Potable Water Expansion Tanks

Project Name: Webster University-**ISB**

Copies	No.	Description
1 PDF	223400P01B	(Submittal No.'s:)
		(Cannon #22 3400-010-REV002) - (Paric #15051-0317) – (WES #607)
		➤ Water Heater Product Data Resubmission
		(Fuel Fire Domestic Water Heater)

PROJECT NAME: Webster University ISBLOCATION: St. Louis MissouriCLIENT PROJ. No.: N/AWES PROJ. No.: 607SPEC SECTION: 223400
Fuel Fire Domestic
Water HeaterSUBMITTAL ITEM:: See Below -CONTRACTOR: Deluca Plumbing, LLC.CTR. SUBMITTAL # 22 3400-010 REV002SUBMITTAL DATE: November 09, 2016DATE RECEIVED: November 10, 2016RECEIVED VIA: E-MailRECEIVED FROM: WTADATE RETURNED: NOVEMBER 13, 2016RETURNED VIA: E-MAILRETRURNED TO: WTASHOP@WMTAO.COM

Selection

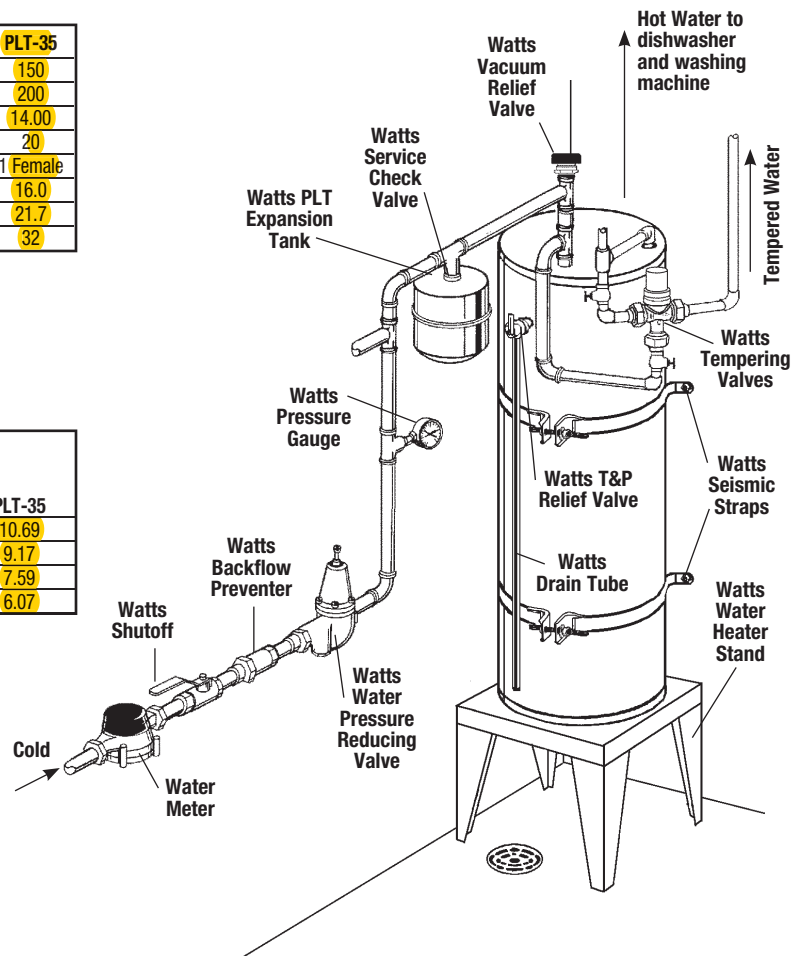
Verify correct size
